**MAUNA KEA SCIENCE RESERVE: COMPLEX
DEVELOPMENT PLAN
FINAL ENVIRONMENTAL IMPACT STATEMENT**
MAUNA KEA, HAMAKUA, HAWAII January 1983

This Final Environmental Impact Statement consists of Volume 1 of the draft EIS, as revised; comments received during the public review period of the draft EIS; and, responses to reviewers comments. Volume 2 of the draft EIS, Technical Appendices, is hereby incorporated by reference, in its entirety, into this Final EIS.

The Final EIS for the Mauna Kea Science Reserve CDP, which was filed with the Environmental Quality Commission (EQC) on 4 January 1983, contains revisions and additions to Volume 1 of the draft EIS. Volume 2, Technical Appendices, was not reprinted but was incorporated into the Final EIS by reference. The revised pages, together with the letters received during the review period and our responses, are attached for your information. (Note: Material in parentheses () has been deleted, underlined material has been added). The following changes were incorporated into the Final EIS:

**MAUNA KEA PLAN MANAGEMENT AREAS
MAUNA KEA SCIENCE RESERVE CDP — FIG. 3**

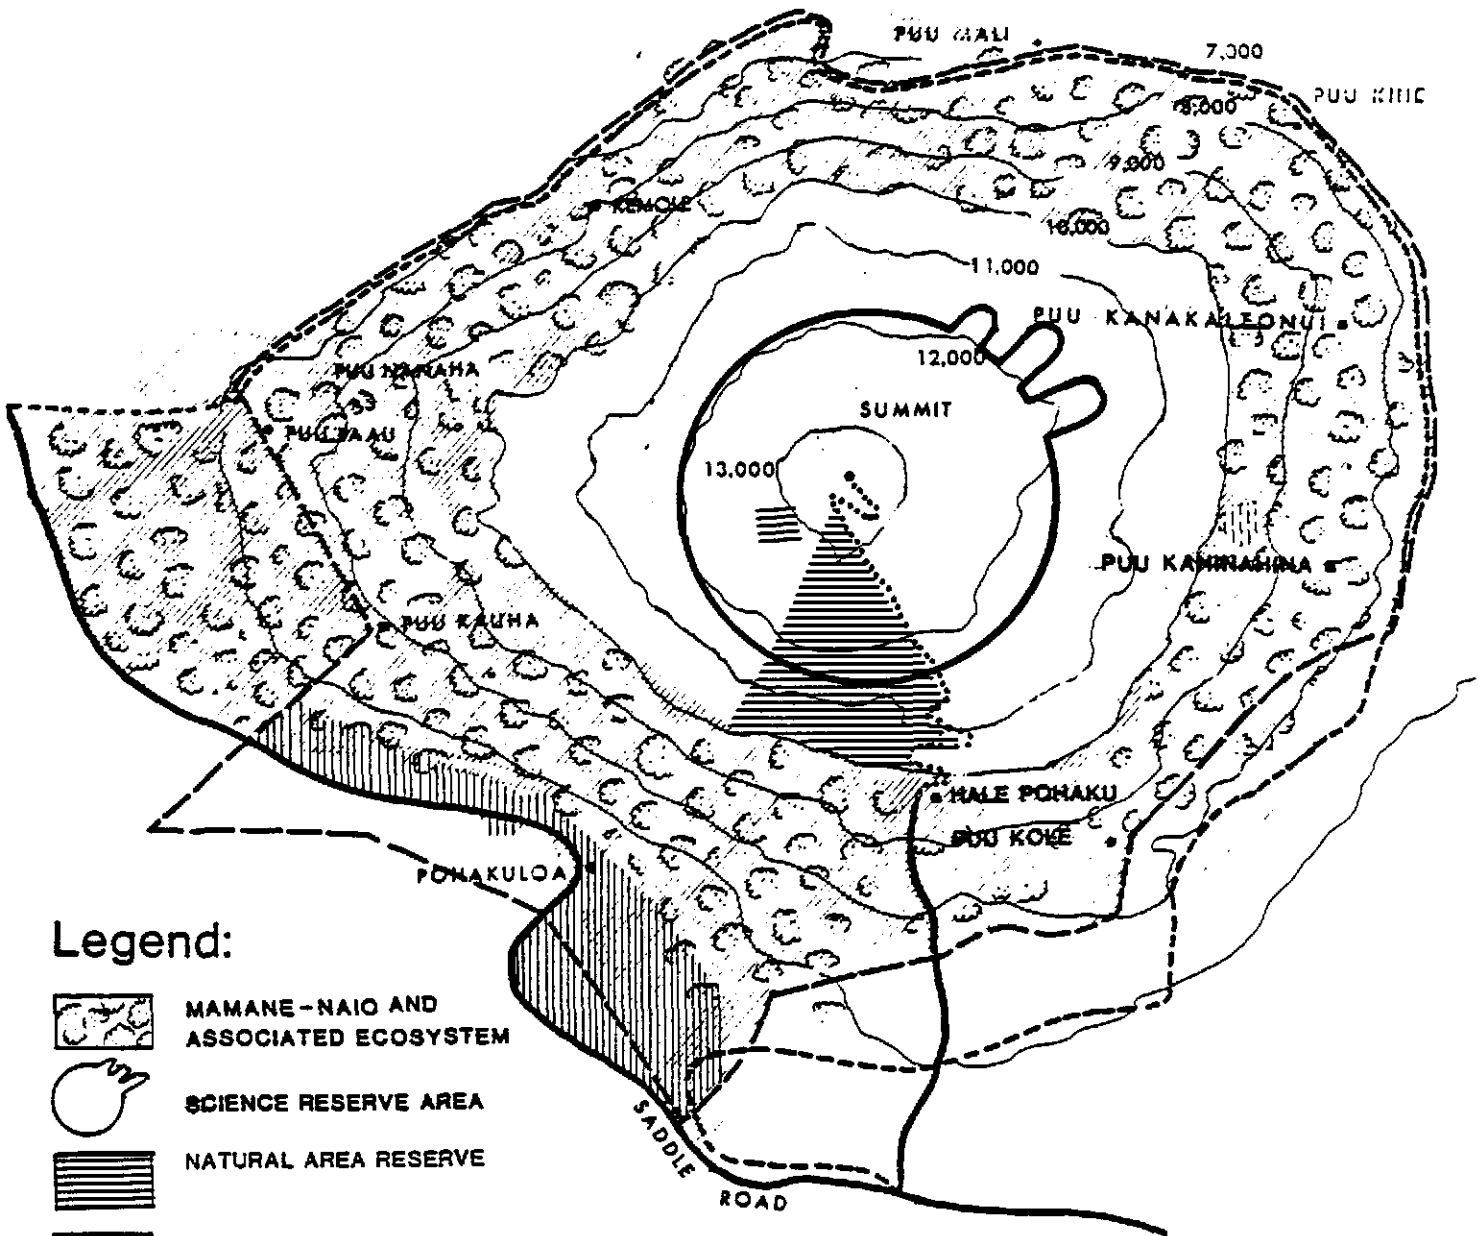
6. Page 7, Figure 3: The title of the map is "Mauna Kea Plan Management Areas". It was inadvertently omitted from the original graphic.
7. Page 17, Para. 1: Amendments to the 1977 DLNR Mauna Kea Plan (may) will be required. . .

MAUNA KEA SCIENCE RESERVE CDP — FIG. 4

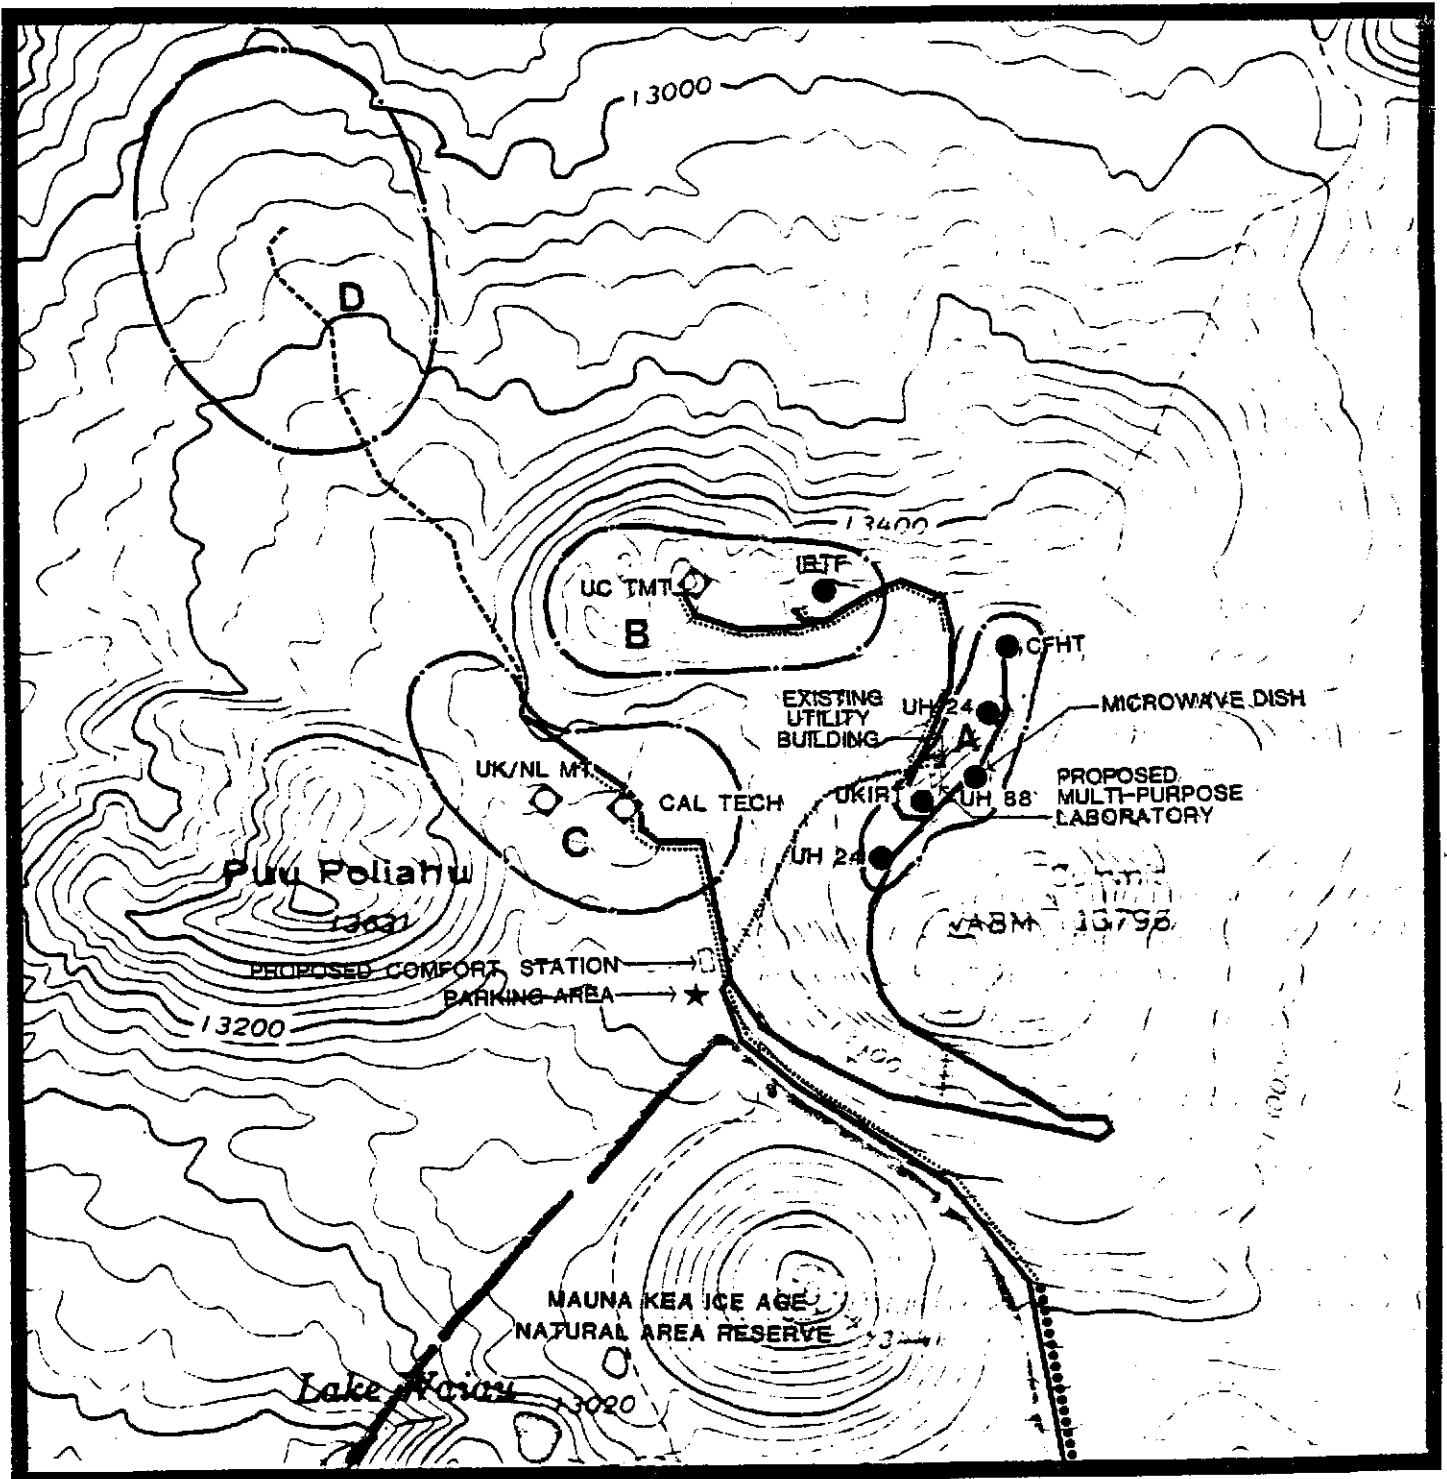
8. Page 19, Figure 4: Puu Pohaku, is identified on the revised Master Plan map as being N.A.R. Pt. 2. It was inadvertently omitted from original graphic.

**PROPOSED PHYSICAL PLAN FOR THE SUMMIT TO YEAR 2000
MAUNA KEA SCIENCE RESERVE CDP - FIG. 5**

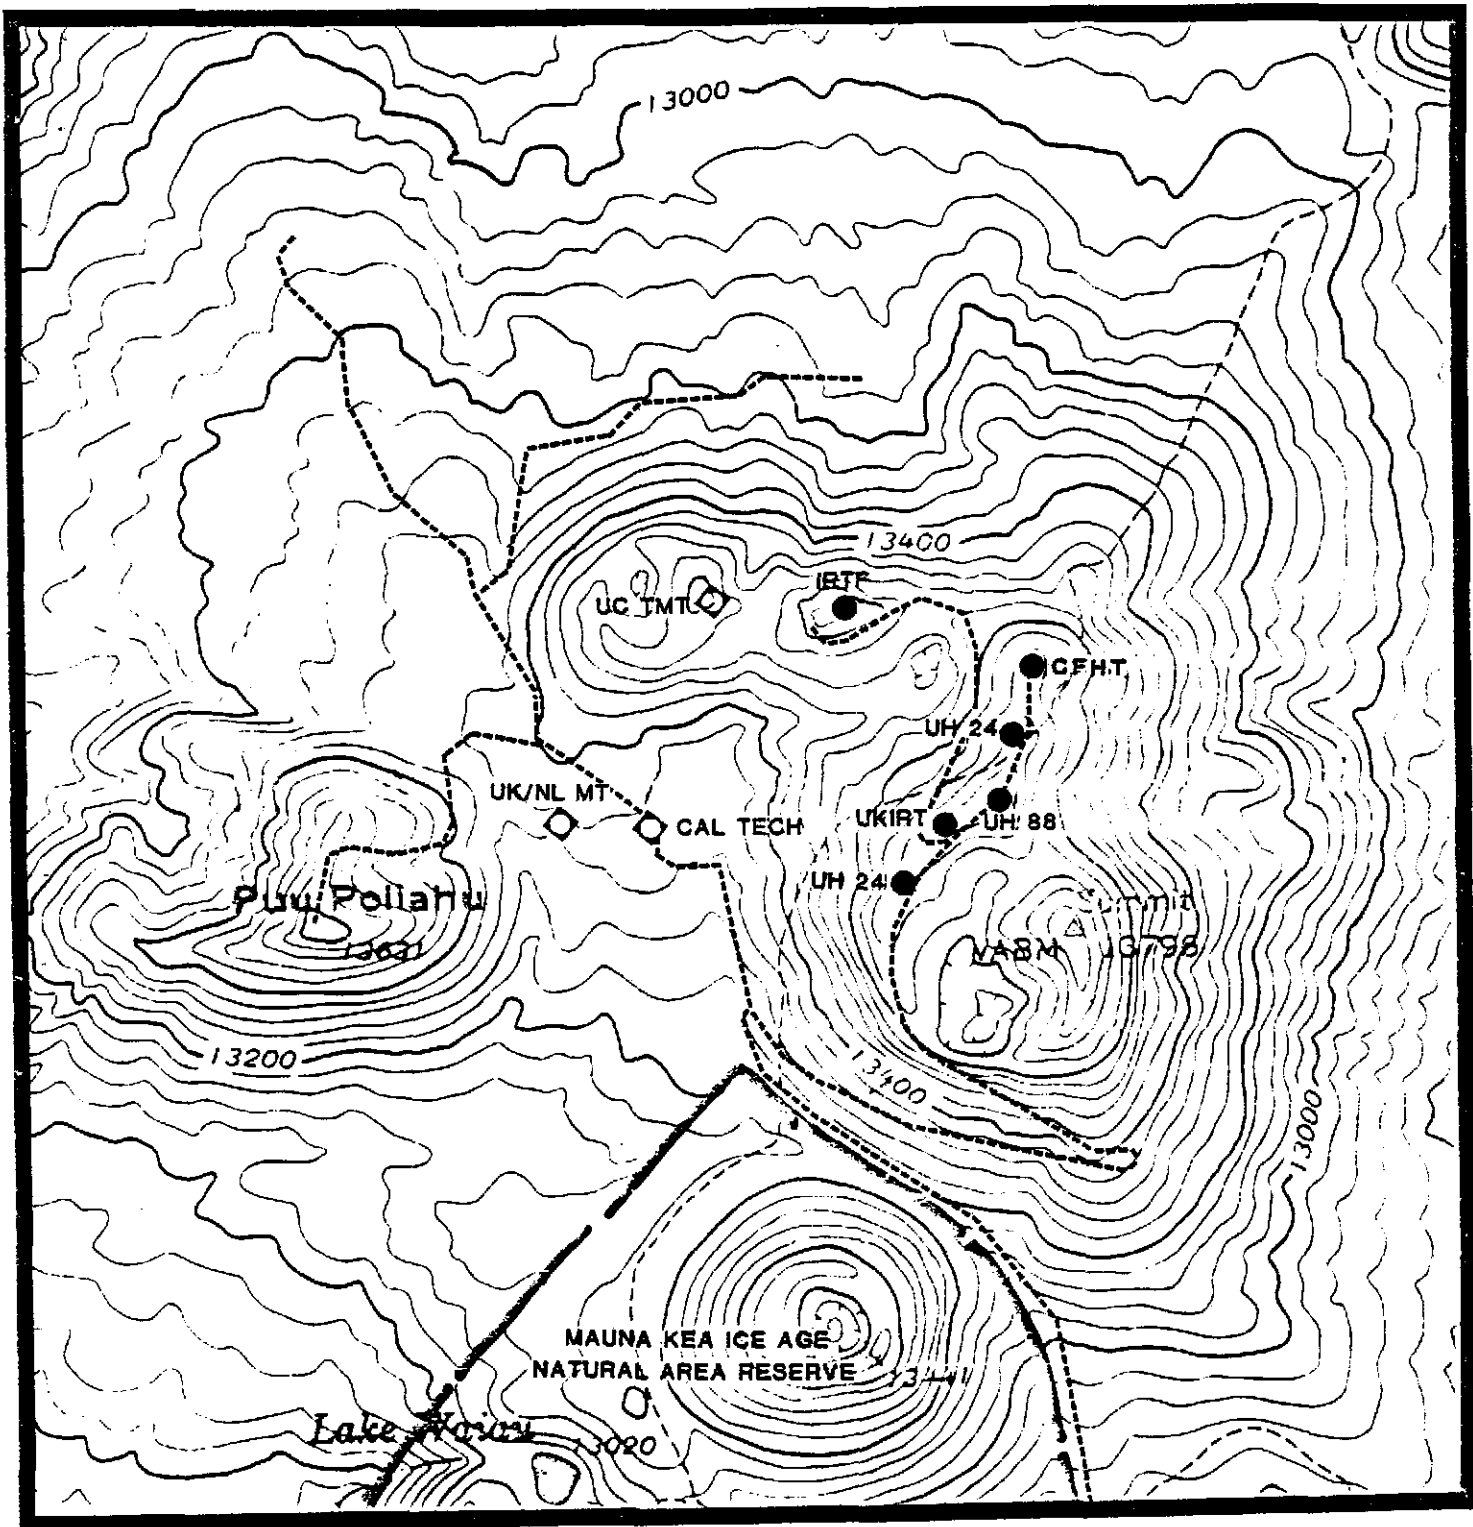
9. Page 20, Figure 5: Recommended siting areas were labeled A, B, C and D.

The parking area was relocated to the south of the comfort station.
10. Page 21, Figure 6: (CHFT) CFHT

MAUNA KEA SCIENCE RESERVE CDP - FIG. 6

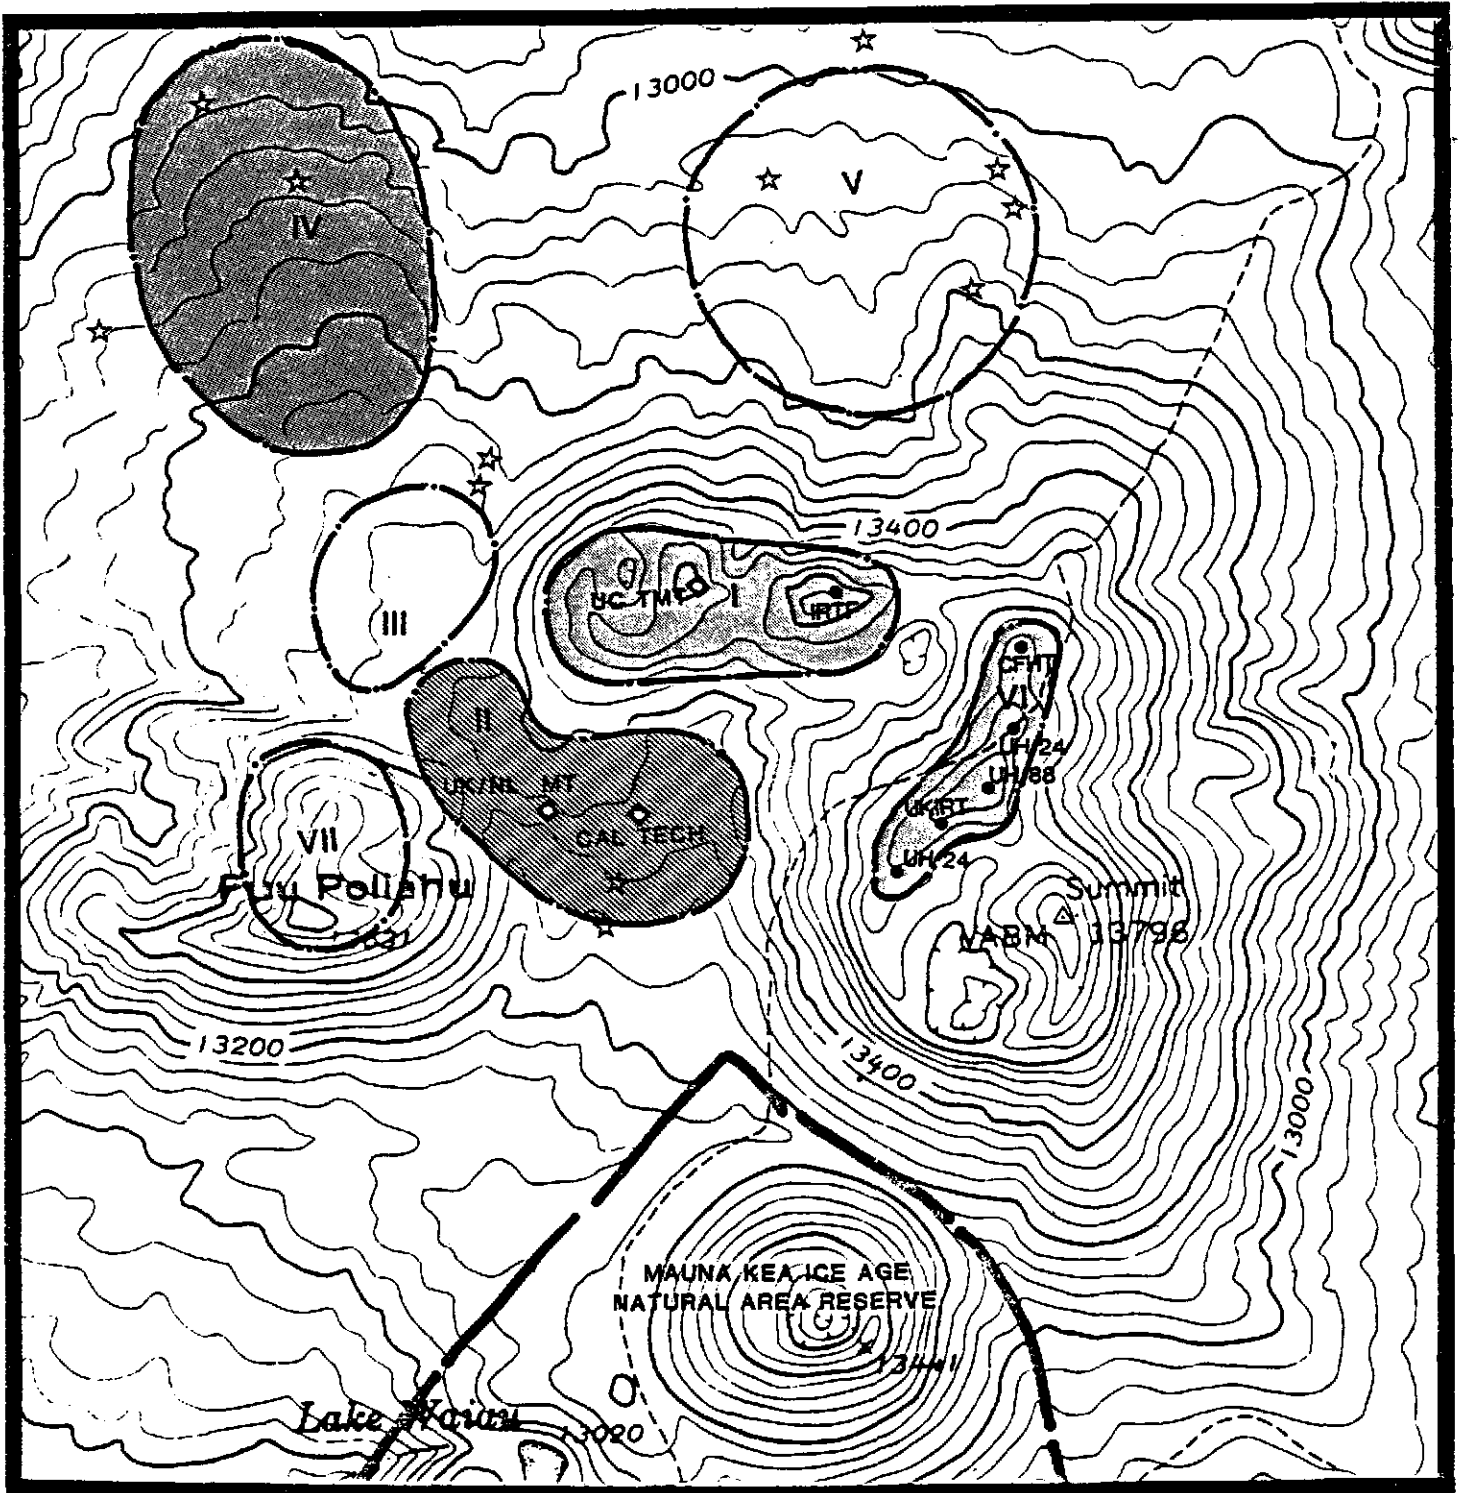
1. Indicating the relevant location for the Mauna Kea Ice Age Natural Reserve would be of benefit. (The reserve is identified elsewhere only on small-scale map figures.) P. 17, Figure 6
